Product / Process Change Notification (PCN)

PCN #: PCN_FeSTAR-RING_20240210

Affected Series: STAR-BUENO; 74275815(S)

DETAIL OF CHANGE:

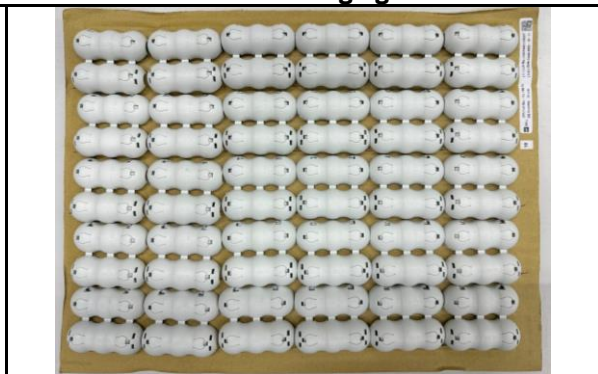
The tray changes in the design and in the size from a double wall corrugated cardboard tray to a paper mould tray. The outer carton box remains the same.

74275815; 74275815S	Unit	New Packaging	Old Packaging
Carton Packaging Quantity (CPQ)	pcs	144	120
Standard Packaging Quantity (SPQ)	pcs	24	30
Number of trays	pcs	6	4
Moisture Impermeable Bag (MIB)		yes	yes
Dimensions of the carton (LxWxH)	mm	400 x 300 x 165	400 x 300 x 165
Dimensions of the tray (LxWxH)	mm	370 x 280 x 12	370 x 280 x 6
Weight of a CPQ	g	7300	6120
Weight of a SPQ	g	1100	1280
